Project	IEEE 802.16 Broadband Wireless Access Working Group < http://ieee802.org/16 >
Title	Improved Stack Diagram
Date Submitted	[2004-03-12]
Source(s)	David Johnston
Re:	Sponsor Ballot Comment against P802.16-REVd_D3 by David Johnston
Abstract	
Purpose	To furnish the stack layering diagram with the correct interfaces and scope.
Notice	This document has been prepared to assist IEEE 802.16. It is offered as a basis for discussion and is not binding on the contributing individual(s) or organization(s). The material in this document is subject to change in form and content after further study. The contributor(s) reserve(s) the right to add, amend or withdraw material contained herein.
Release	The contributor grants a free, irrevocable license to the IEEE to incorporate material contained in this contribution, and any modifications thereof, in the creation of an IEEE Standards publication; to copyright in the IEEE's name any IEEE Standards publication even though it may include portions of this contribution; and at the IEEE's sole discretion to permit others to reproduce in whole or in part the resulting IEEE Standards publication. The contributor also acknowledges and accepts that th

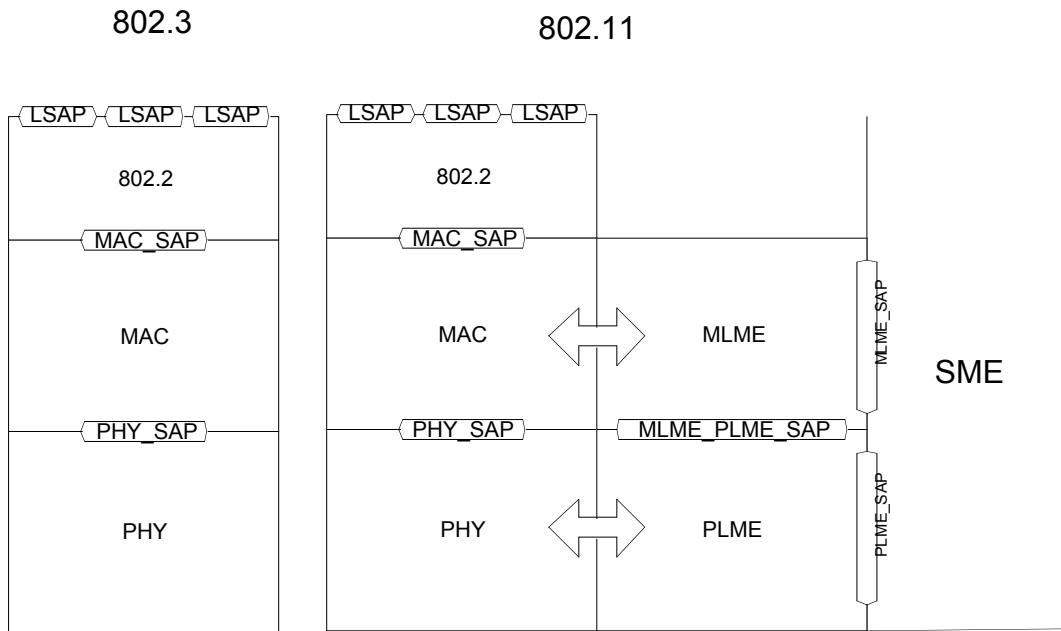
In 802.16e, a CS_SAP has appeared and an MA (Mobility Agent) is defined as a bridging layer, between the CS and some other undefined backhaul network. There is no MA_SAP, nor is there any other type of service defined. 802.16e in this mode is either a network tunnel using the chosen CS protocol type (ATM, IP, 802.1Q or 802.3) as the encapsulating protocol.

Unfortunately, no CS_SAP primitives are defined, so the model is incomplete.

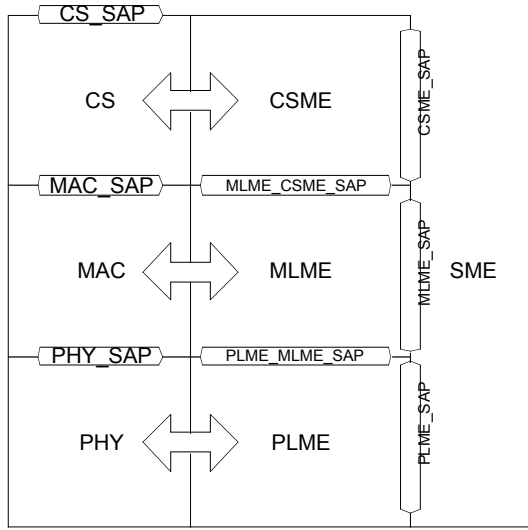
The 802.16e model still has problems. The MA is still defining the BS as being a bridge. There can be no services available at the top of the stack, since there is no upwards data SAP. There needs to be a separate MA defined for each CS.

The MA is defined as being something in the data path. This seems odd, given that an MA usually is concerned with making handover decisions and in some way managing a handover and address mapping. In general it looks like a management function.

In the specification, there are no specific procedures assigned to the MA, so it would be inappropriate for it to exist as a layer in the data stack. Hypothetically it should exist in the SME as an implementation defined function that will be related on the larger system architecture of the BS or MSS. The way that the MA can interact with the stack is through the CSME_SAP, MLME_SAP and PLME_SAP.

802.16e

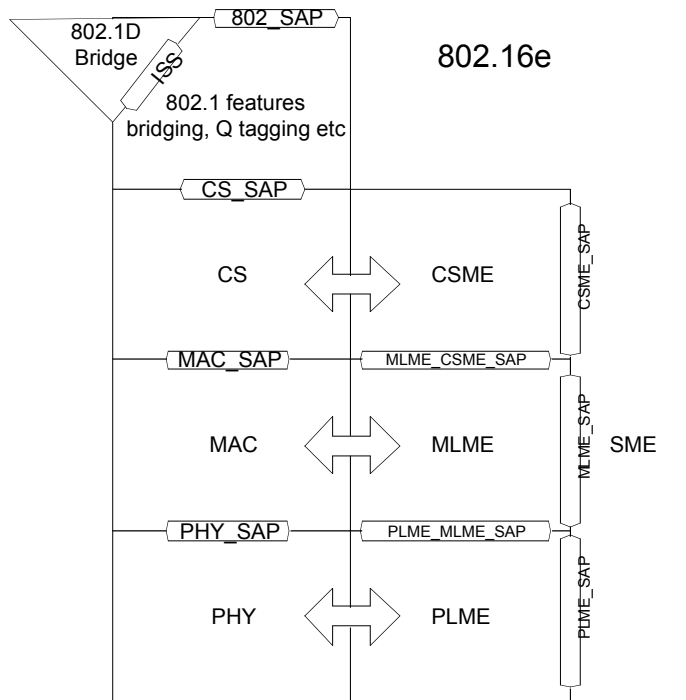
Narrowing in to just the .16e stack, since the MA is in the SME, we do not need to define it, nor do we need to define its interfaces. All we need to define is within the bounds of the CS, MAC, PHY, CSME, MLME and PLME and the interfaces to and between them.

This appears to be much more tractable. We know where the MA does its thing (the SME). We know how it can influence the stack (Through the management SAPs). The stack looks very like the 802.11 stack, except with the addition of the 802.16 style CS. We know what the service is (the CS_SAP).

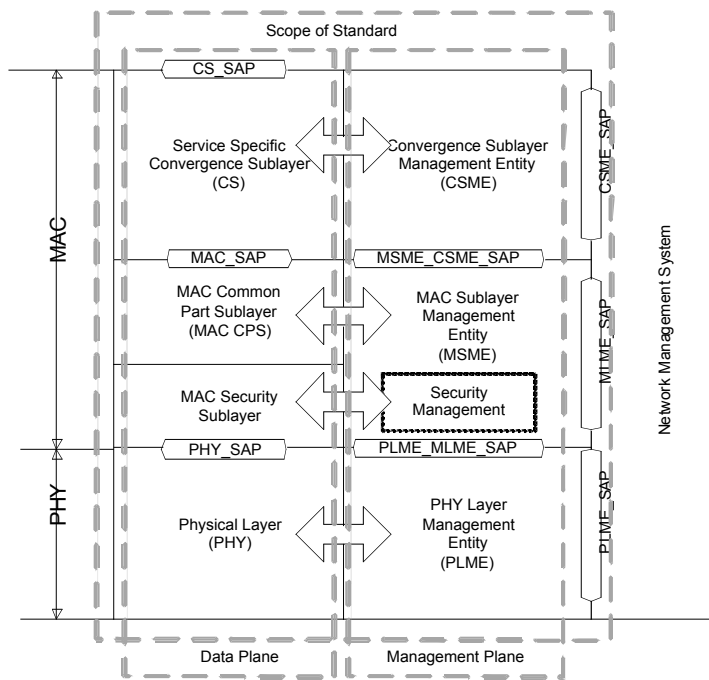
If we want an architecture that is a bridge, consistent with the larger 802 model, the path is clear. We define the top of the CS to be as in 802.1D. There is no need to call out framing for 802.1Q tagging. 802.1Q does that for us. The ISS and the Q tagging is defined in 802.1D and 802.1Q. So we should be removing Q tagging from the 802.1Q packet CS and referring to 802.1Q and 802.D to do the heavy lifting for us. This might look like this:

9
 0 So bringing in the extra information from figure 1 concerning the scope of the standard and the location of the data and
 1 management planes, I propose the following be substituted for figure 1.
